Project: IEEE P802.15 Working Group for Wireless Personal Area Networks (WPANs)

Submission Title: comment and resolution about CID 33, 58, 34 and 59

Purpose: Contribution to IEEE 802.15.7 TG-VLC

Figure 20—Successful data transmission without an acknowledgment

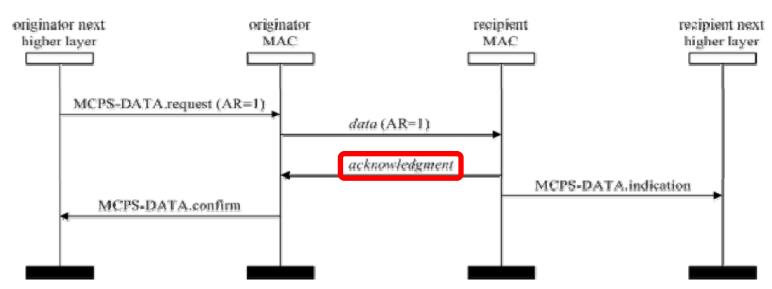
- Comment 33: Figure 20 has the title of "Successful data transmission without an acknowledgment", but the actual figure has AR=1, and shows an acknowledgement. I believe the wrong figure is here
- Comment 58: Text is about "without ACK". Buth the figure 20 describes about with ACK
- Comment 59: In "without ACK" case, AR should be "0". But AR=1 in figure 21.

- Comment 33: Put in the correct figure
- Comment 58: Change figure 20 with figure 21
- Comment 59: Change "AR=1" to "AR=0" in figure 21

- Resolution/instruction to editor
 - Change figure 20 with figure 21
 - Change AR=1 to AR=0
 - Subclause 5.1.7.4.1, page 46, line 26
 - In this case, the originator transmits the data frame with the Acknowledgment Request (AR) subfield of the frame control field equal to zero.

Figure 21—Successful data transmission with an acknowledgment

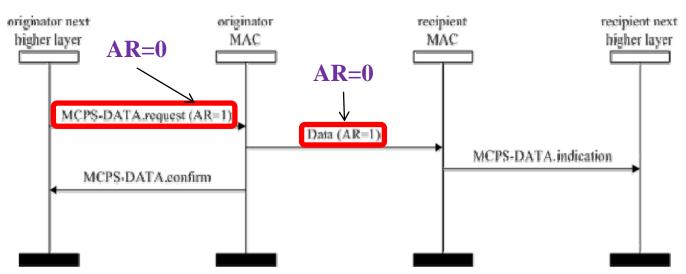
- Figure 21 has the title of "Successful data tr ansmission with an acknowledgment", but t he actual figure shows without an acknowle dgement.
- Comment is wrong.

Put in the corrected figure

- Resolution/instruction to editor
 - Change figure 21 with figure 20
